Motor News Page 1/2

# Notice on Changes to the Terminal Block Labeling for Shin-G Series Compact AC Geared Motors

G-Series Compact AC Geared Motors - With Seal Connector

## ■ The Changes

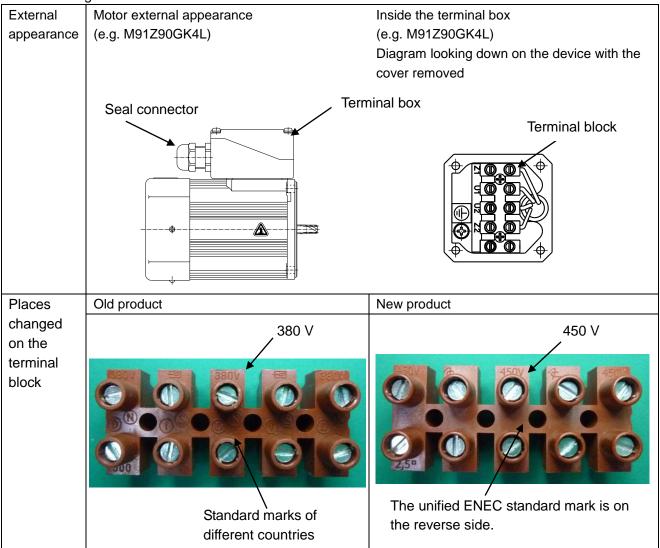
(1) The European safety standards labeling on the terminal block will change due to its unification under the ENEC standard only, in place of the various safety certifying labels of each country. There is no change to the North American standards labeling.

Note: The unified ENEC mark and the North American standard mark are displayed on the reverse of the terminal block and cannot be seen from the outside.

(2) Due to changes in the European safety standards, the rating mark will change from 380 V to 450 V.

• This change will have no effect on product dimensions, properties or reliability.

The materials are also unchanged, so there is no effect on substances with environmental impact.
